KOKO + Hope & Anchor

Second Floor

MTT FIRE

Fire Strategy Commentary

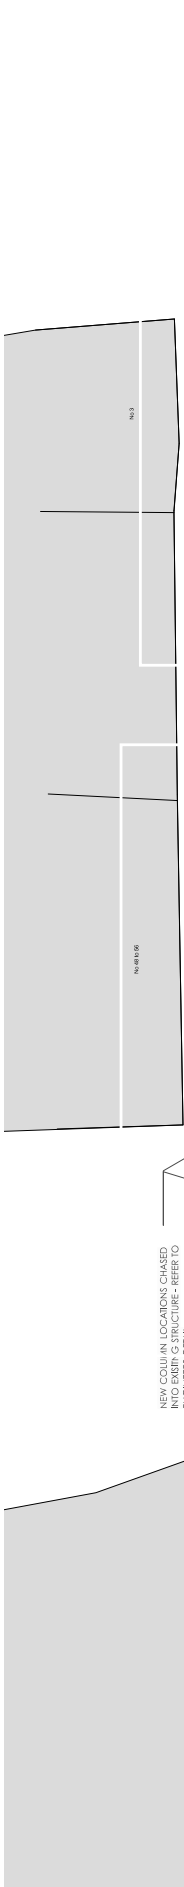
pantry kitchen as single stair part of building. propose that strategy is developed with escape through the stair and to corridor as alternative or new door to corridor adjacent to lift 1?

facade study required with regards to boundary separation

small dead end part of corridor ~3m permitted

fire protected escape corridor with escape in alternative directions

protected lobby approach to stair enclosure.

consider fire rating of glass between events space and suite

arrange as protected stair enclosure.

maximum travel distance within bedroom should be <9m. travel distance of 10.5m in this instance permitted as maximum travel distance in bedroom corridor is significantly shorter than max distance of 9m so travel from furthest point in bedroom to storey exit ~ 16m, against max permitted distance of 18m
